***MODIFICATION REQUEST:  
DHL Logistics Hub Modification 4  
Site 1A, Oakdale Central Industrial Estate,  
Horsley Park (08\_0066 MOD4)***

***Modifications to the layout of the  
warehouse/distribution centre on site 1A***

Director-General's  
Environmental Assessment Report  
Section 75W of the  
*Environmental Planning and Assessment Act 1979*

September 2012

**Figure 4: Proposed Modified Layout**

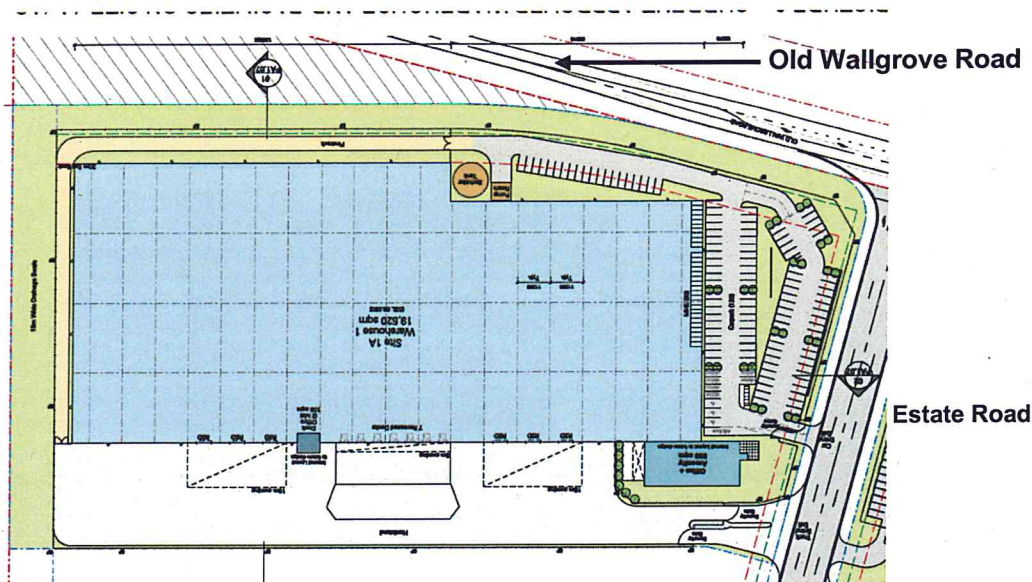
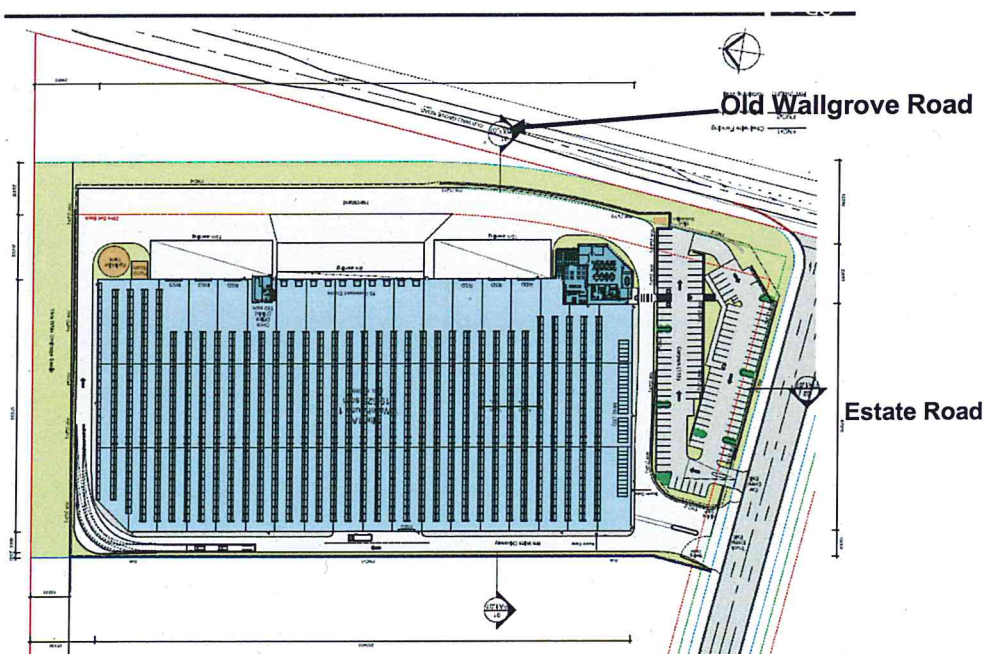
Approval is sought for amendments (MOD 4) to the development as previously modified, essentially to reorient and reposition the warehouse to be constructed on Site 1A, with associated relocation of the loading areas and minor associated amendments to site facilities, refer to **Figures 3 and 4**.

The warehouse building will be rotated 180 degrees and be sited in a position which will be similar to that originally approved, prior to the initial modification of the Stage 1 project approval. The proposed use of the building as a warehouse and distribution centre will be unaffected by the modification. The key aspects of the proposed modification are listed in **Table 1**.

**Figure 5: Comparison of original approval with current approved development and as proposed to be modified**

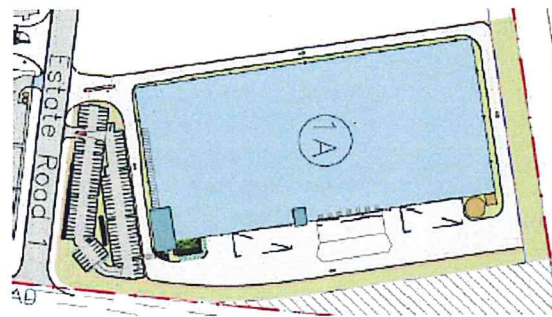
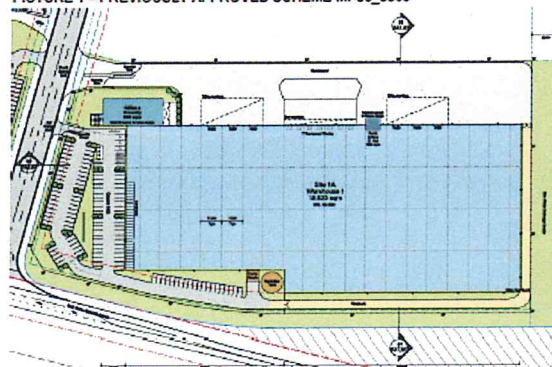
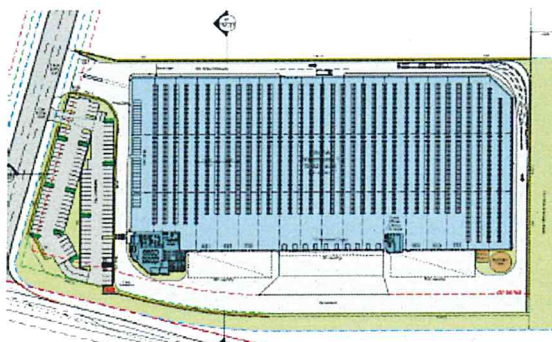
The built form of the warehouse building will remain substantially the same, with the changes related to reorientation of the building on the site and repositioning so that the loading areas face towards Old Wallgrove Road. This will reposition the approved building so that its modified site layout will be similar to the site layout as originally approved, prior to amendments approved under Modification No 1, refer to **Figure 5**.

While 'back of house' activities and delivery/loading areas of the modified development will be now be visible from the frontage to Old Wallgrove Road (and the future link road) this was the case with the development as originally approved, refer to **Figure 5**. This also will not be inconsistent with similar warehouse distribution facilities within the area, and will be consistent with the existing warehouses on Site 2A where these 'back of house' activities are visible from the frontage to the estate road, refer to site photos in **Appendix B**. It will provide for some activation to this elevation of the development. It is also noted that the building will in part be located below the level of Old Wallgrove Road, and there will be a 10m wide landscaped setback to ensure there is a suitable street frontage.
